**ITEM 6.2:** Design Review Permit – 10051 Fairway Dr. – HRNSP PCL 45A – Dutch Bros – PL21-0015

**REQUEST**

Request for a Design Review Permit to allow construction of a 930-square foot Dutch Bros coffee house with drive-thru in the northwest corner of an existing parking lot along Fairway Drive.

**Figure 2. Site Plan Including Proposed Striping**

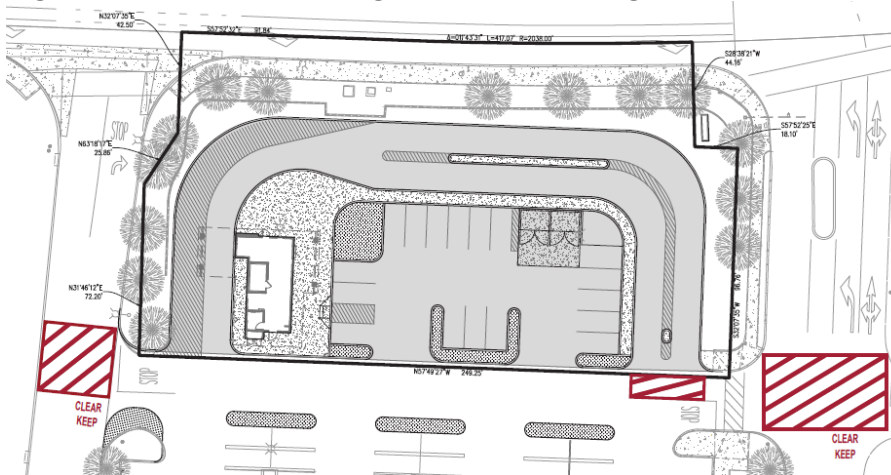
**Vehicle Access & Circulation:** The proposed access and circulation was designed based on the recommendations made in the traffic study (Attachment 1). Access to the site will be provided by existing driveways on Fairway Drive. CDG Policy CC-30 requires a minimum of 180 feet of stacking space from the entrance of a drive-through lane to the pick-up window to prevent conflict with other vehicle circulation on the project site. The proposed double drive-through lanes provide approximately 425 feet of stacking, which is well above the minimum stacking requirement and would accommodate approximately 21 vehicles. As recommended in the traffic study (Attachment 1), striping will also be added at three locations leading to the project site to discourage drivers from idling in intersections of drive aisles within the Home Depot parking lot. City Engineering staff reviewed the vehicle stacking design and determined it to be adequate based on similar drive-through establishments in the City. No impacts from overflow parking or vehicle queuing are anticipated on the adjacent roadways. The project was also reviewed by the City Fire Department staff and was found to comply with emergency circulation requirements.

23. Per the Traffic Evaluation performed by Kimley-Horn January 20<sup>th</sup>, 2021, the applicant shall provide “KEEP CLEAR” pavement markings in case of spillback to the public right-of-way. In addition, pavement markings shall be added to keep the entrance to the drive-thru clear and running efficiently. See Exhibit 5 of the Traffic Evaluation for the needed pavement marking limits.

25. The project shall incorporate all proposed recommendations from the Traffic Evaluation prepared by Kimley-Horn, dated January 20<sup>th</sup>, 2021, in particular Exhibit 5 – Pavement Markings Concept.
